HIGHWAY WORK PROPOSAL

COUNTY	STATE PROJECT ID	FEDERAL PROJECT ID	PROJECT DESCRIPTION	HIGHWAY
Dane	1206-07-84	WISC 2014 260	Mount Horeb-Madison Verona Road to Seminole Highway	USH 18
Dane	1206-07-85		Mount Horeb-Madison Madison Beltline (Phase 3)	USH 18

ADDENDUM REQUIRED ATTACHED AT BACK

CONSTRUCTION DETAILS - MSE WALL JOINT AESTHETIC DETAILS

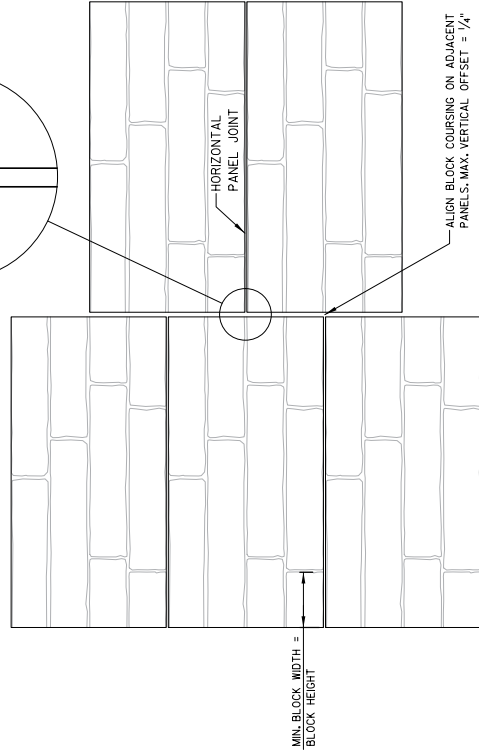
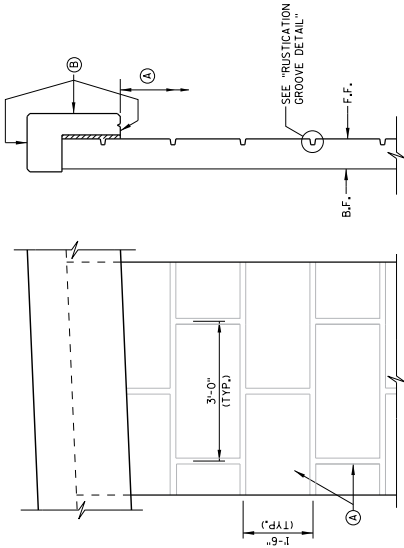
Addendum No. 1
IDs 1206-07-84 &
1206-07-85
Revised Sheet 98
June 26, 2014

TYPICAL PANEL JOINT CROSS SECTION

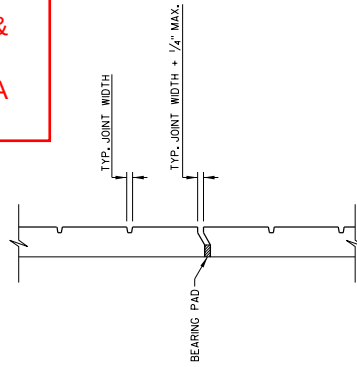
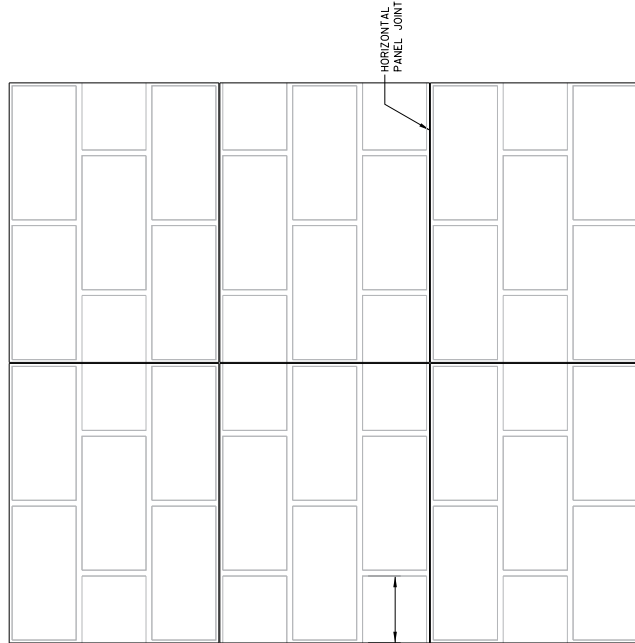
Addendum No. 1
IDs 1206-07-84 &
1206-07-85
Added Sheet 98A
June 26, 2014
